# **Final Summary of Comments and Responses**

Statewide Clean Water Act Section 303(d) List Portion  
of the 2024 California Integrated Report

Finalized date:  
March 13, 2024

**STATE WATER RESOURCES CONTROL BOARD**  
CALIFORNIA ENVIRONMENTAL PROTECTION AGENCY

**Figure 1:** Streamflow, in cfs, for USGS Gaging Station 11070500 (Canyon Lake Spillway) for the February 2017 Storm Event

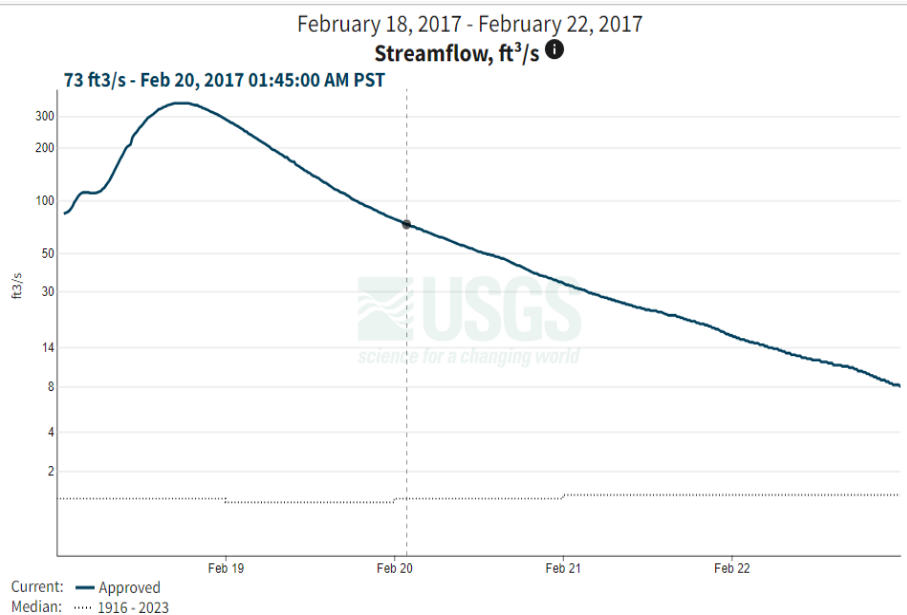
No.	Comment	Response
		There is only one other sample (LOE ID 307254) that exceeds the aluminum criterion for total aluminum and one exceedance is not sufficient to support a listing decision.
024.07	Accordingly, the evidence in the record indicates that there is no threat of impairment of the intermittent beneficial uses and that San Jacinto River Reach 1 should not be listed for aluminum.	Changes to listing recommendations were made in response to this comment. For more information, see response to comment 024.06.
